DOCTYPE: LETTER NOTARIZED: NO COPIES RECEIVED
SUBJECT: LTR 1 ENCL 10
RESPONSE TO NRC LTR DTD 02/23/78... FORWARDING ADDL INFO OF REPT NEDM-20988,
"CAORSO RELIEF VALVE LOAD TESTS - TEXT PLANT" WHICH WAS SUBMITTED BY GE ON
BEHALF OF THE MARK II OWNERS GROUP.

SUBJECT: MARK II CONTAINMENT REQUEST FOR ADDITIONAL INFORMATION

RESPONSE TO NRC COMMENTS OF JULY 7, 1977 AND FEBRUARY 23, 1978
ON CAORSO TEST PLAN

FIG. 5-2A PIPE AND QUENCHER TEMPERATURE SENSORS

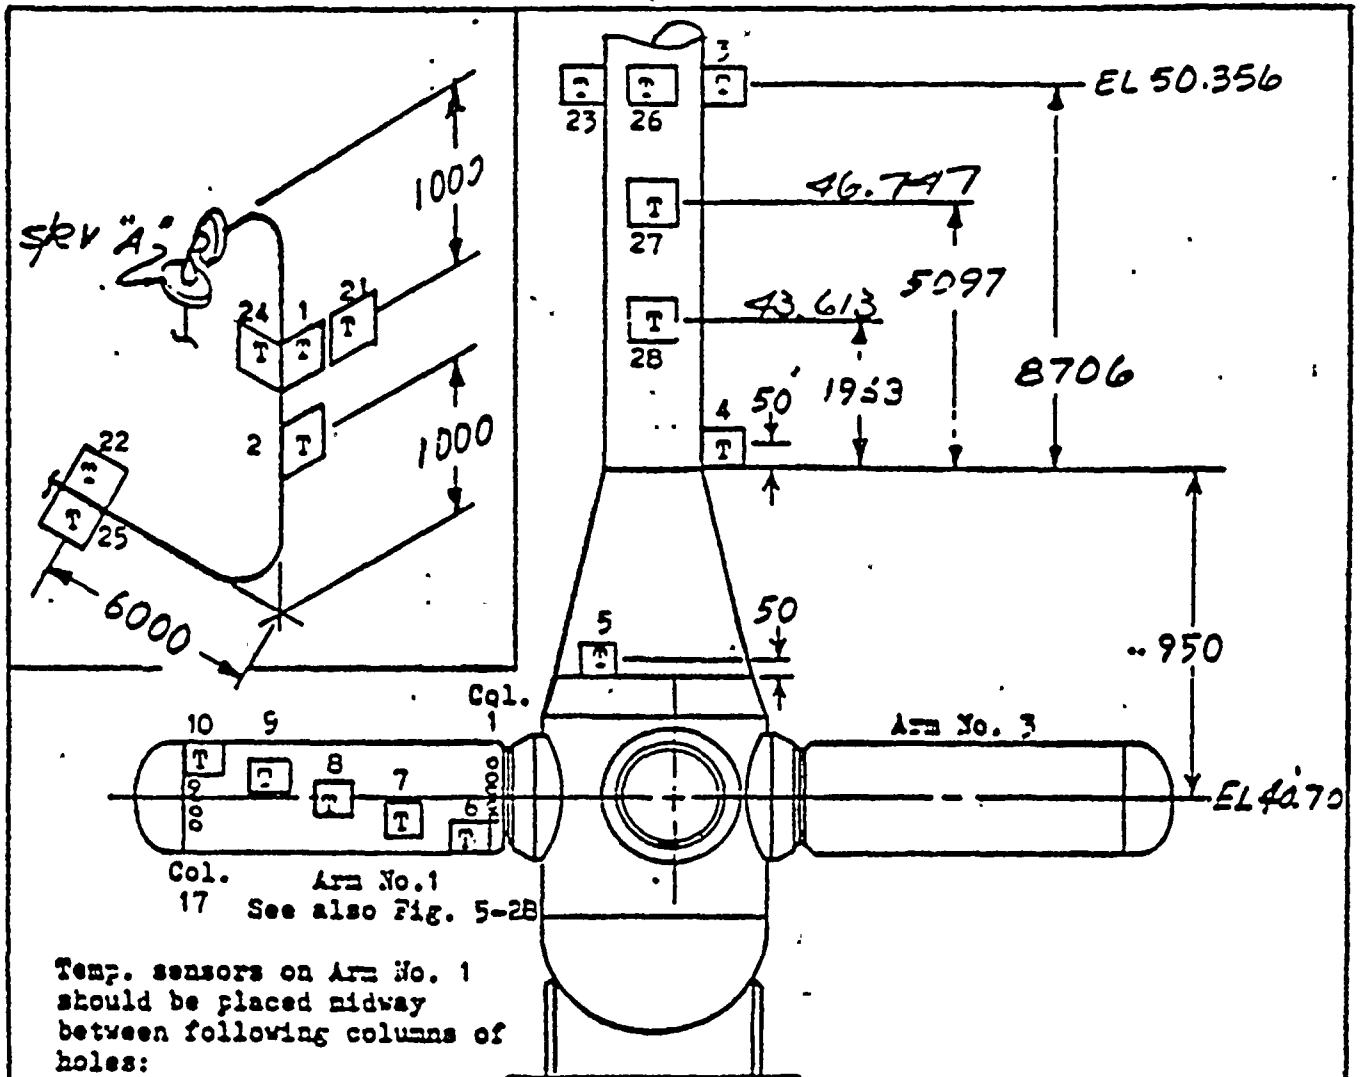
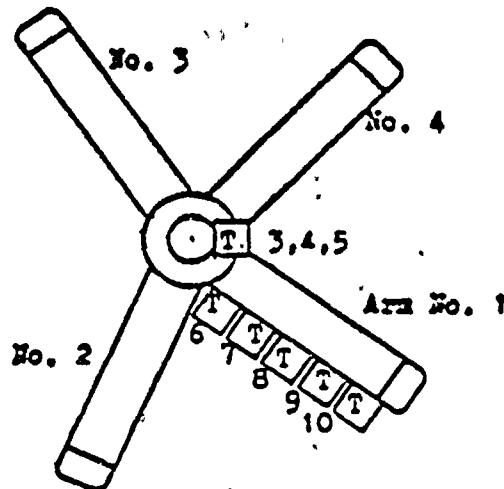
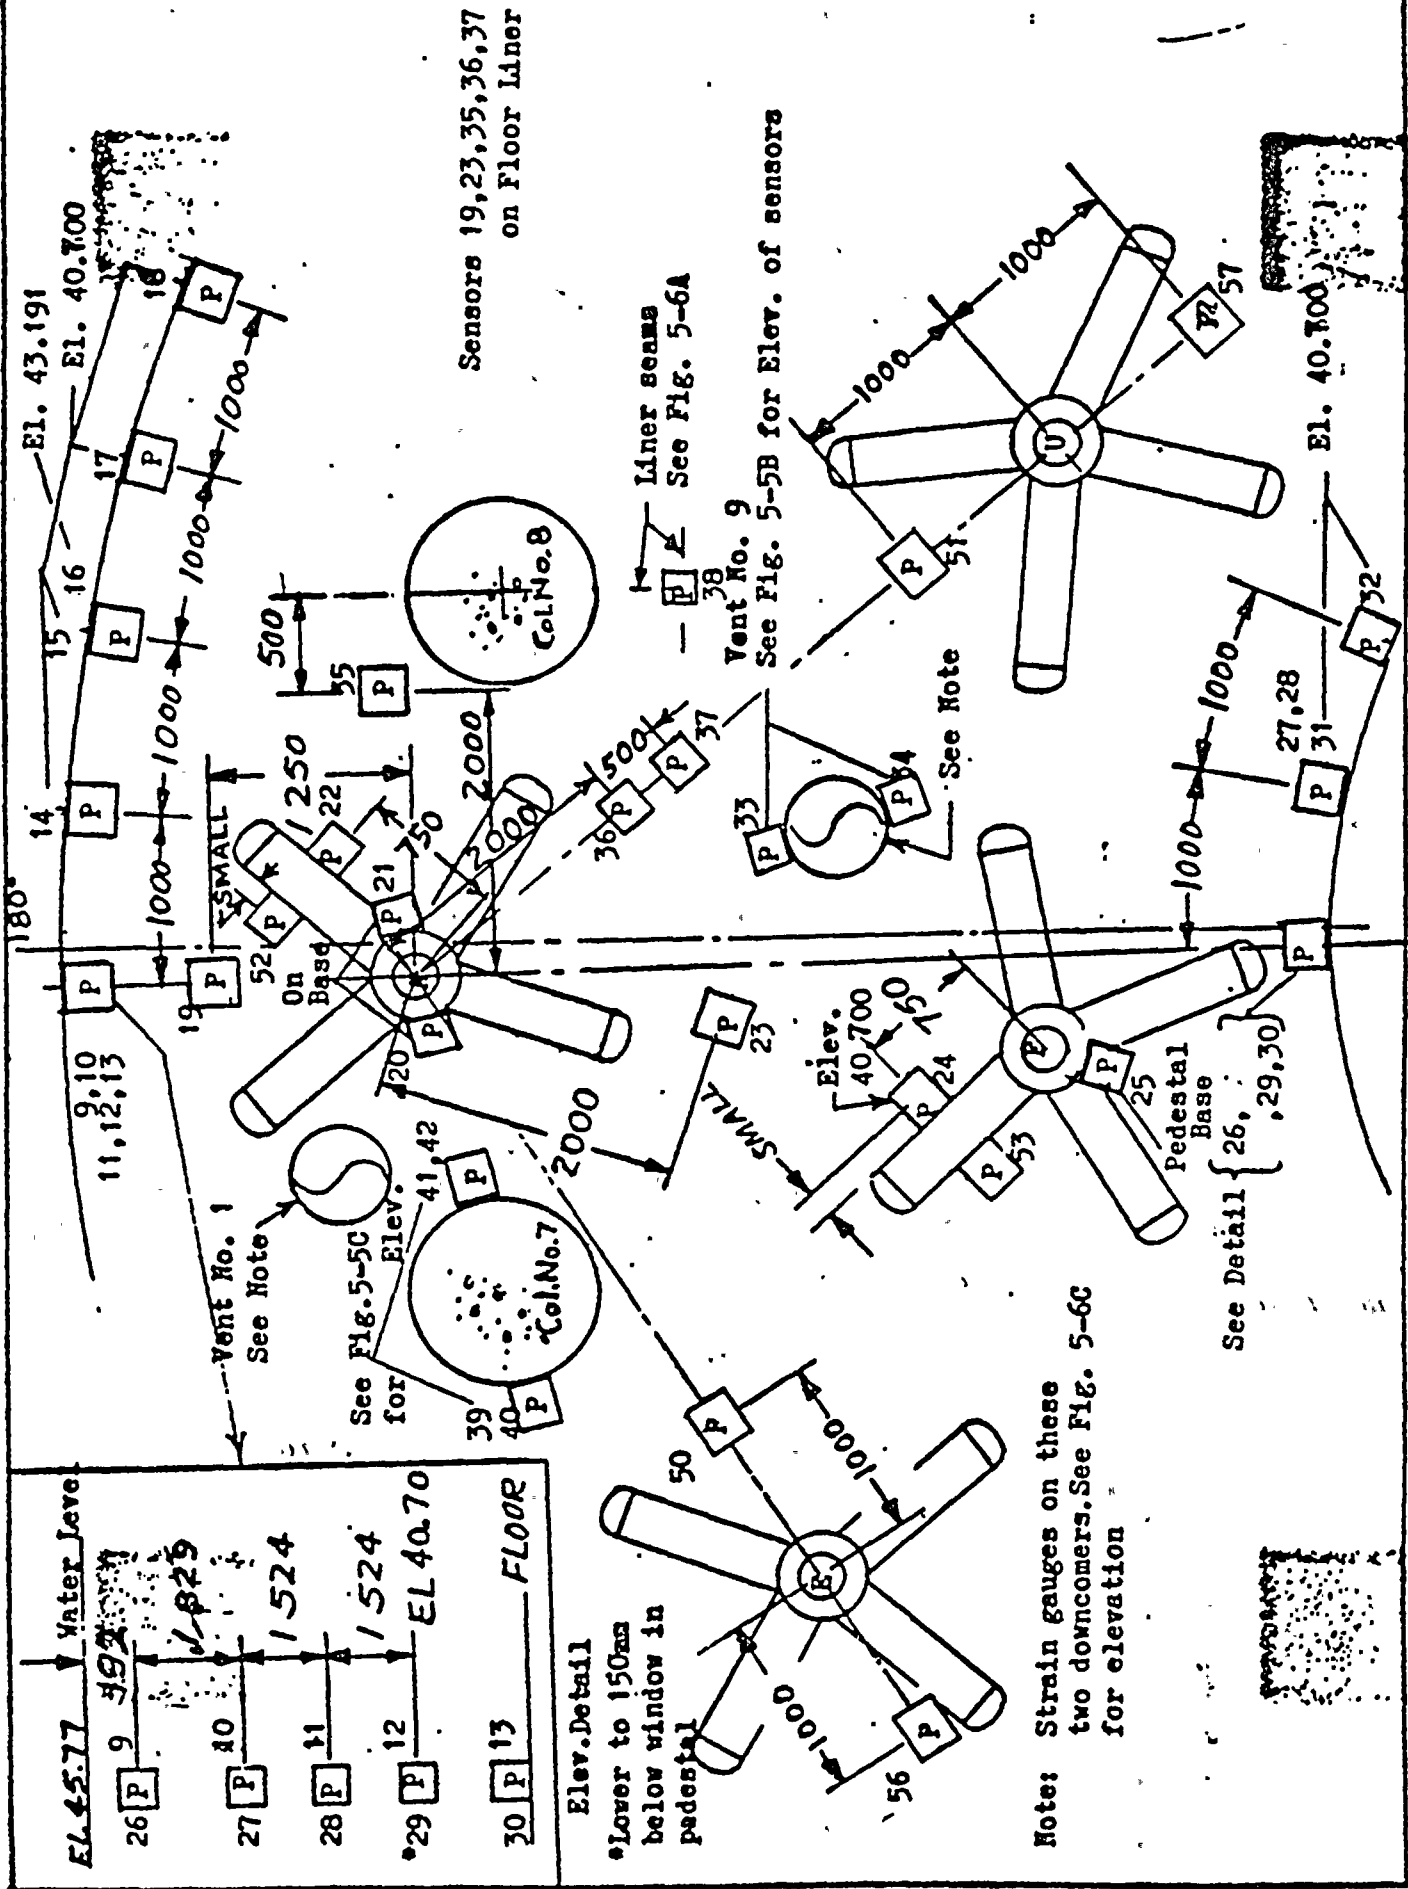
Page 4-6 states that a complete understanding of the subsequent actuation effect requires data on pool temperature in the vicinity of the quencher, pipe temperature and pressure following valve closure, flow rate of air through the vacuum breaker and dynamics of back flow of water. We agree that the air temperature history inside the pipe could be important. However, insufficient information has been given in the test plan regarding the measurement of air temperature in the pipe. Clarify what measurements or calculations will be made to monitor this temperature.

The temperature history of the saturated air-steam mixture inside the SRV discharge line will be measured using sensors T1, T2, T3, and T27 (See attachment (2)). These sensors are designed to measure the temperature of the environment in the discharge line, not the temperature of the discharge line wall. The temperature of the saturated air-steam mixture can be verified using the methods described below.

For the first actuation, the saturated air-steam mixture temperature can be approximated as being equal to the temperature of the discharge pipe inner wall. This temperature will be measured on sensors T24, T25, and T26 (see attachment (2)). For sequential actuations, the air mass will be measured as it enters the discharge line through the vacuum breaker. Given this measured air mass, the discharge line pressure and the total discharge line air-steam mixture volume at the end of the water reflood transient, the temperature of the gas mixture can be calculated using the ideal gas laws by assuming that the steam in the mixture is at saturation corresponding to the discharge line pressure.

- (3) Temperature sensor T3 (see attachment (2)) can be used to provide additional water level information between sensors L1 and L12 if required.

With regard to the question of redundancy for level probes between elevations 51.612 and 45.770, temperature sensors T3, T4, T5, T27, and T28 can function as level sensors if required and will provide redundancy for the level probes in case of failure.

FIG. 5-5A POOL PRESSURE SENSORS

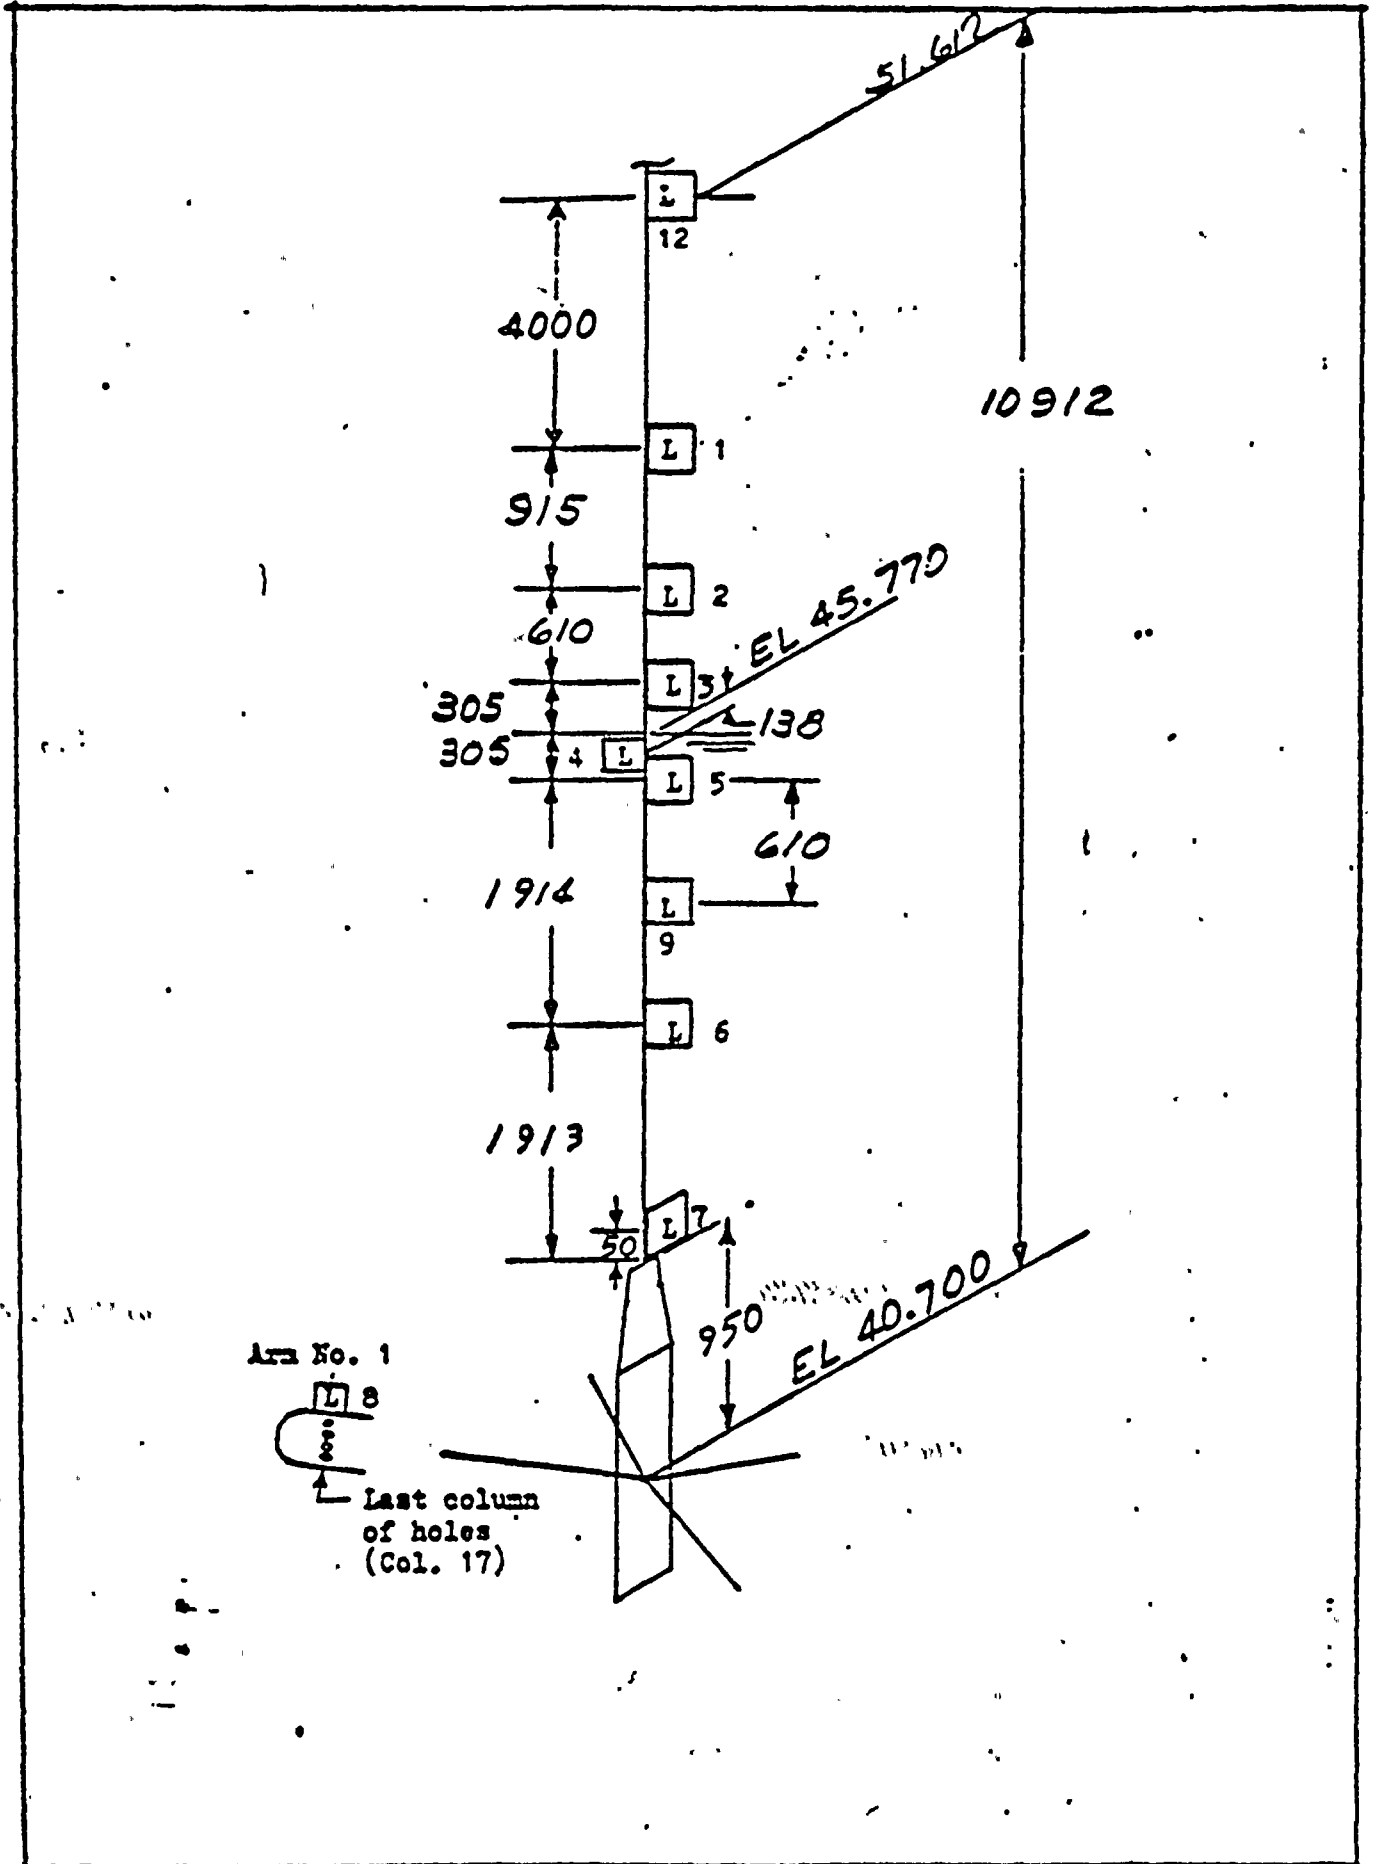
Provide the locations for pressure sensors Nos. 19, 23, 35, 36, and 37.

The locations of these sensors are shown in attachment (3).

Sensors 19, 23, 35, 36, 37 on Floor Liner

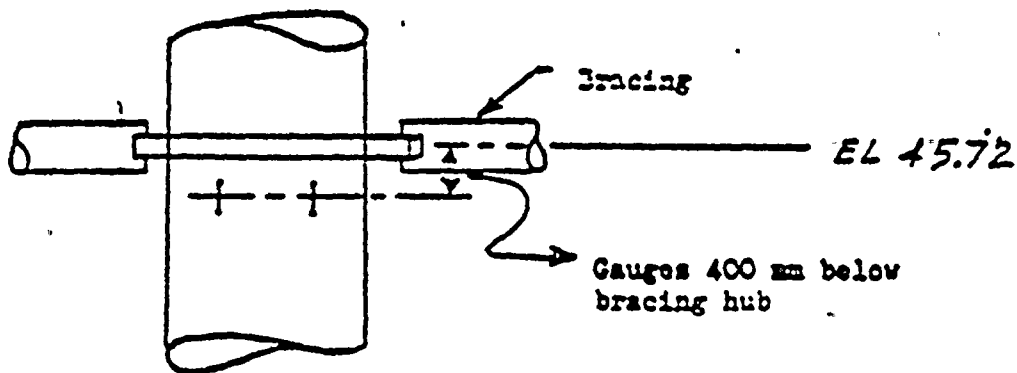
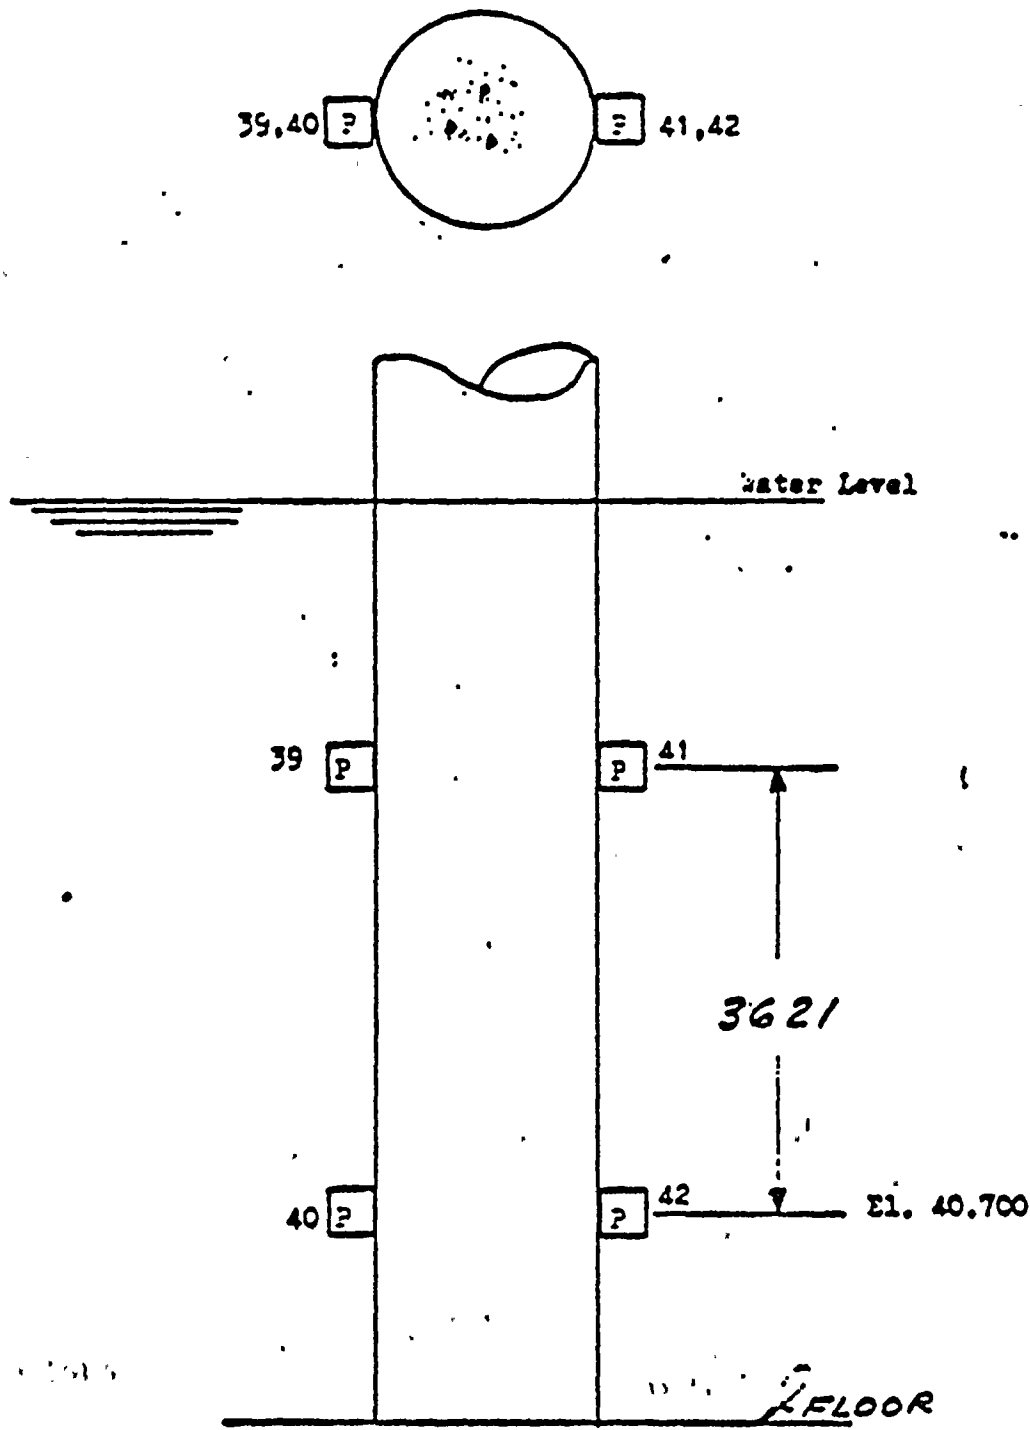
Submerged structure loads have been identified as a primary design load for the Mark II containment. We believe that the analytical program indicated in the Mark II Owners Group meeting which was held on February 16 and 17, 1977, is insufficient to support the design loads for submerged structure without experimental data. Therefore, we recommend that additional pressure sensors should be installed on support columns and downcomers to measure the drag load during SKV operation.

Measurements on two downcomers and a support column adjacent to Quencher A will provide the needed loads information. The instrumentation used, which is shown in attachments 6, 7 and 8 consists of the following:

1. Strain gauges on vents Nos. 1 and 9.
2. Pressure transducers on Support Column No. 7 and Vent No. 9.

Note: Four uniaxial gauges to be located at 90° intervals around circumference on 2 selected downcomer vents (see Fig. 5-51 for location). Pairs of diametrically opposed strain gauges to be connected to read moments. Orientation of gauges relative to containment axes to be recorded.
